USB Power Delivery ENGINEERING CHANGE NOTICE

Title: USB PD R3.2 V1.0 – EPR Request in SPR Mode
Applied to: USB Power Delivery Specification Revision 3.2
Version 1.0

Brief description of the functional changes proposed:
This ECN explicitly states that a Source should initiate a HardReset sequence if Sink sends it an EPR_Request message while in the SPR mode of operation

(a) Section 6.4.9 EPR_Request Message, Page 220

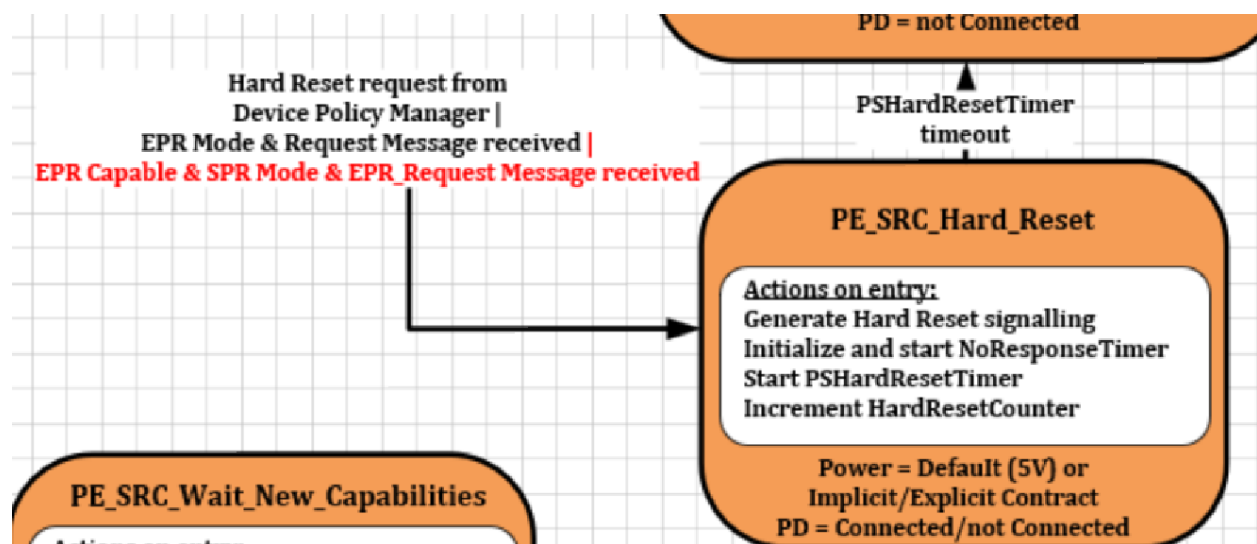
The Source *Shall* respond to an *EPR_Request* Message in the same manner as it responds to a *Request* Message with an *Accept* Message, or a *Reject* Message (see *Section 6.9 “Accept, Reject and Wait”*). A Sink receiving a *Wait* response *Shall* initiate a Hard Reset. The Explicit Contract Negotiation process for EPR is the same as the process for SPR Mode except that the *Source_Capabilities* Message is replaced by the *EPR_Source_Capabilities* and the *Request* message is replaced by the *EPR_Request* message.

The Source *Shall* respond to an *EPR_Request* Message in the same manner as it responds to a *Request* Message with an *Accept* Message, or a *Reject* Message (see *Section 6.9 “Accept, Reject and Wait”*). A Sink receiving a *Wait* response *Shall* initiate a Hard Reset. The Explicit Contract Negotiation process for EPR is the same as the process for SPR Mode except that the *Source_Capabilities* Message is replaced by the *EPR_Source_Capabilities* and the *Request* message is replaced by the *EPR_Request* message.

An EPR Source operating in SPR Mode that receives a *EPR_Request* Message *Shall* initiate a Hard Reset.
